# Freescale Semiconductor Addendum

Document Number: MPC8536ERMAD

# Errata to MPC8536E PowerQUICC III™ Integrated Processor Reference Manual, Rev. 1

This errata describes corrections to the MPC8536E PowerQUICC III<sup>TM</sup> Integrated Processor Reference Manual, Revision 1. For convenience, the section number and page number of the errata item in the reference manual are provided. Items in bold are new since the last revision of this document.

Figure 10-19. External Termination of GPCM Access (PLL Bypass Mode)

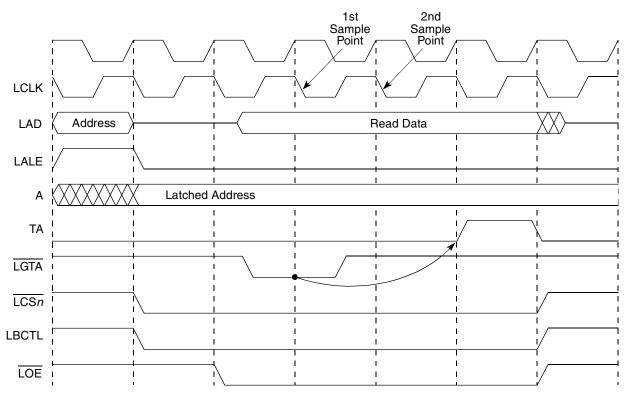
| 11.5.4, 11-23    | Remove first sentence from the third paragraph, as follows: "The I <sup>2</sup> C controller automatically generates a STOP if I2CCR[TXAK] is set."   |
|------------------|---|
| 13.4.2.4, 13-58  | Relabel existing Figure 13-45 as "External Termination of GPCM Access (PLL Enabled Mode)." Add new Figure 13-46 as follows:   |

In PLL bypass mode, the timing of  $\overline{LGTA}$  is illustrated by the example in Figure 10-19.

Figure C-1. MPC8535E Block Diagram

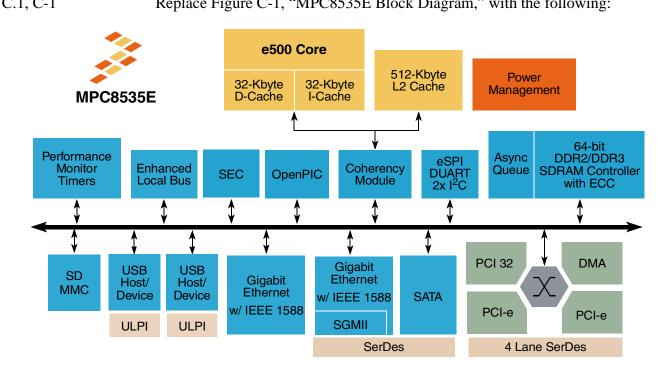
| Section, Page No. | Changes   |
|-------------------|---|
| C.1, C-1          | Replace Figure C-1, "MPC8535E Block Diagram," with the following:   |
